Technical Service Bulletin

Subject: FRONT AND REAR BRAKE NOISE	Bulletin No.: 04-001/23
	Last Issued : 09/13/2023

2013-~~2024~~ CX-5

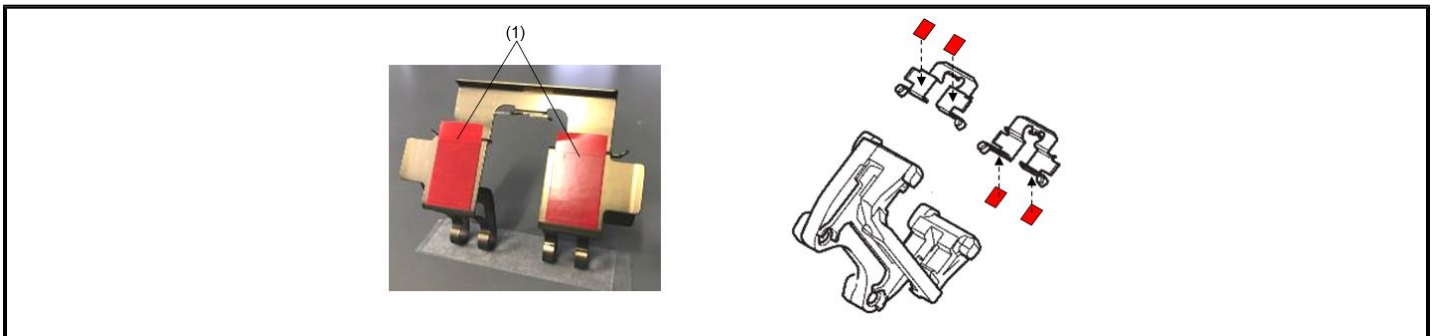
- Verify if the tape is installed to both guide plates (some kits do not have the tape installed and is packaged separately).
- If the tape is not applied to the guide plates, peel off the red release film (1) and the dual adhesive tape (2) from the release paper (3) and apply the dual adhesive tape to the contact surfaces of the guide plates as shown below.
